# MANUAL CHANGES

**Model Number:** 8690B  
**Date Printed:** August, 1968  
**Part Number:** 08690-90007

This supplement contains important information for correcting manual errors and for adapting the manual to instruments containing improvements made after the printing of the manual.

Figure 1. Component Identification, A3 Assembly (Part of Change 1)

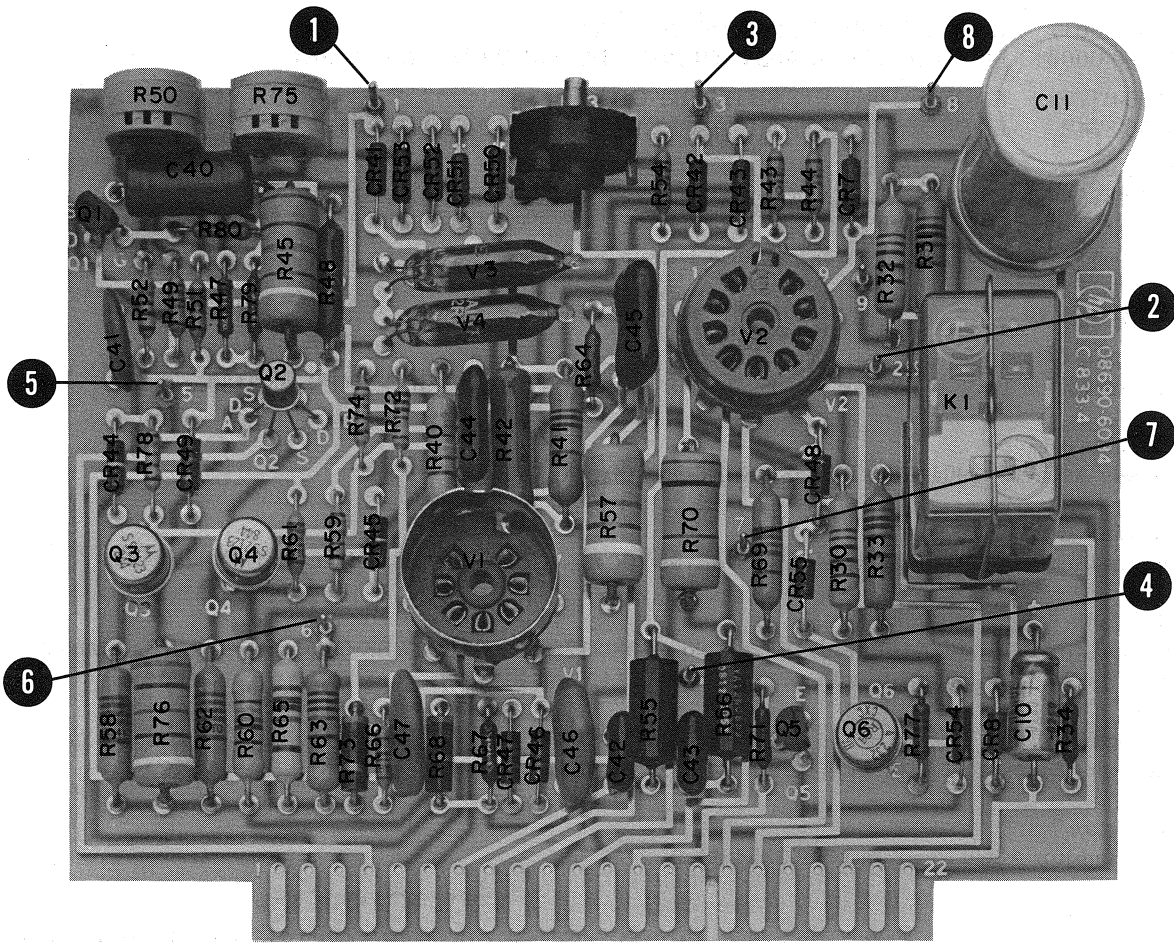
Add resistor A3R80, 10K. (Connect one end to gate lead of A3Q1 and the other end to capacitor A3C40.)

Substitute the attached photo (Figure 1) for the A3 Assy.

Figure 2. Partial Schematic of AC Primary Circuit (Part of Change 7)

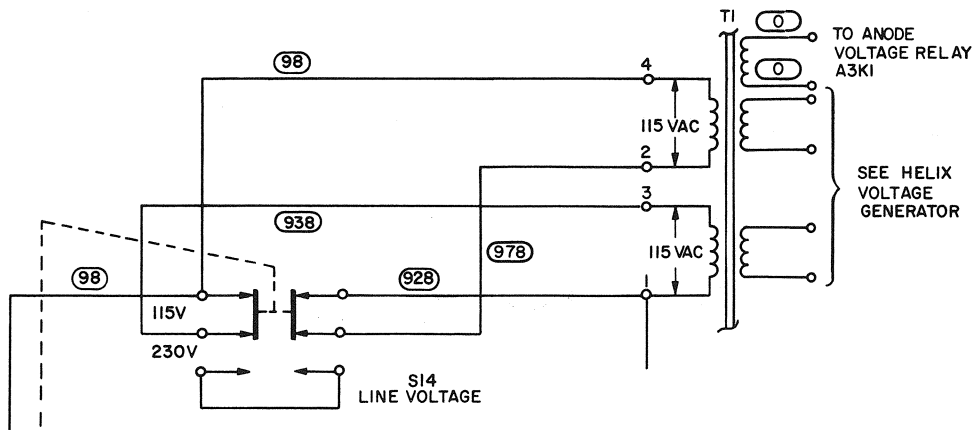
Change primary power circuit as indicated in attached partial schematic (Figure 2).

Figure 3. Component Identification, A8 Assembly (Part of Change 11)

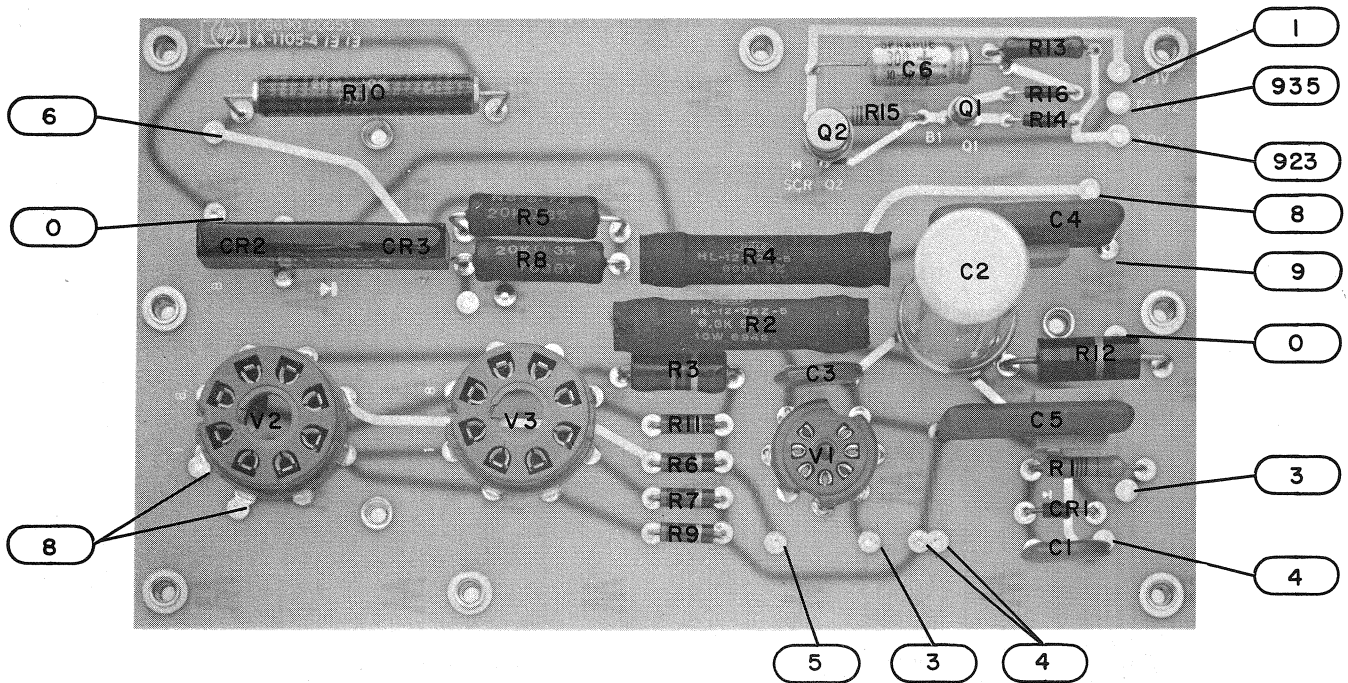
Substitute the attached A8 Assy board photo (Figure 3) for the photo shown in the manual.

Substitute the attached A8 Assy, component Identification board photo (Figure 3) for the photo shown in the 8690B Manual.

Figure 4. Component Identification, A14 Assembly (Part of Change 12)

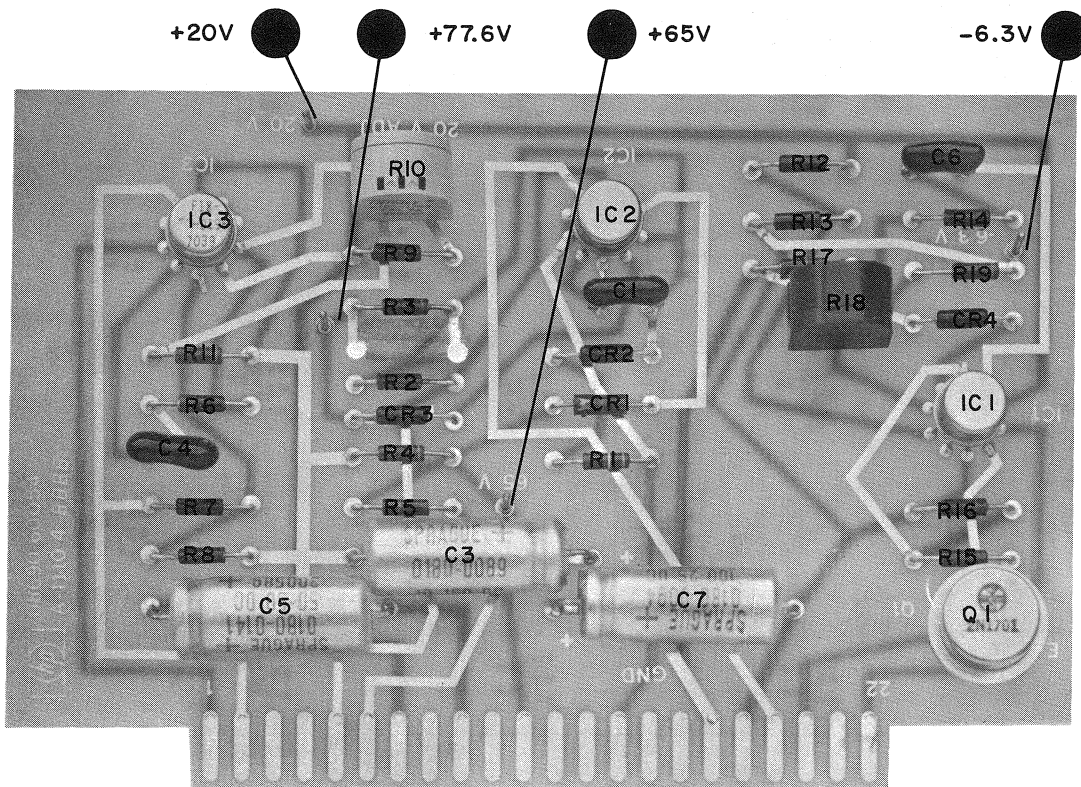
Substitute the attached A14 Assy board photo and schematic (Figures 4 and 5) for those shown in the 8690B Manual.

Figure 6. Component Identification, A4 Assembly (Part of Change 15)

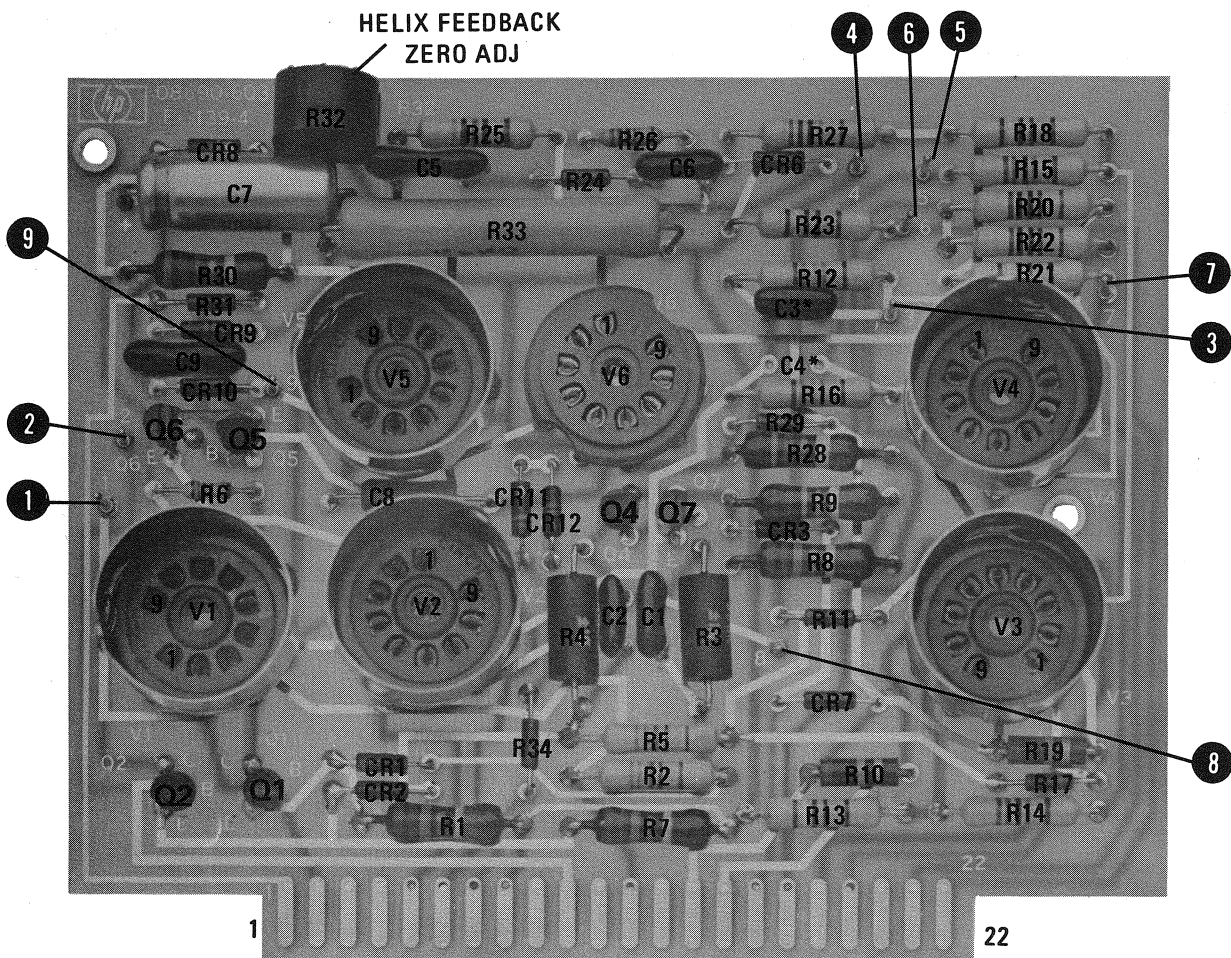
Substitute the attached A4 Assembly component Identification photo (Figure 6) for those shown in the manual.
